# Access Compliance Report

## Public Rights-of-Way

### (Curb Ramps)

Intersection ID: 54218	Main Street: GOLF_LINKS_DR	Cross Street: SANDY_ROCK_PL	Location: SW
ADA ID: D0F332D447EF	Ramp Type: Directional1	Initial Pass/Fail: Fail	Overall Compliance: No
			Severity Score: 13.75

#### Codes/Mitigation Info/Possible Solution

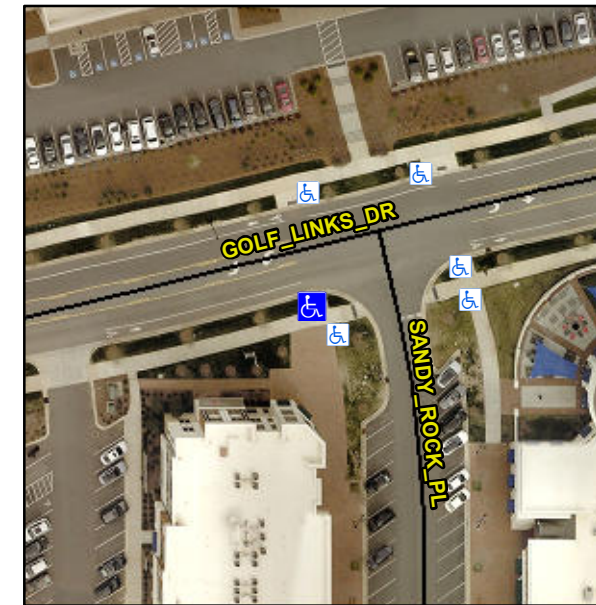
**R304.2.2, R304.5.3**

**Remove & Replace Entire Ramp.**
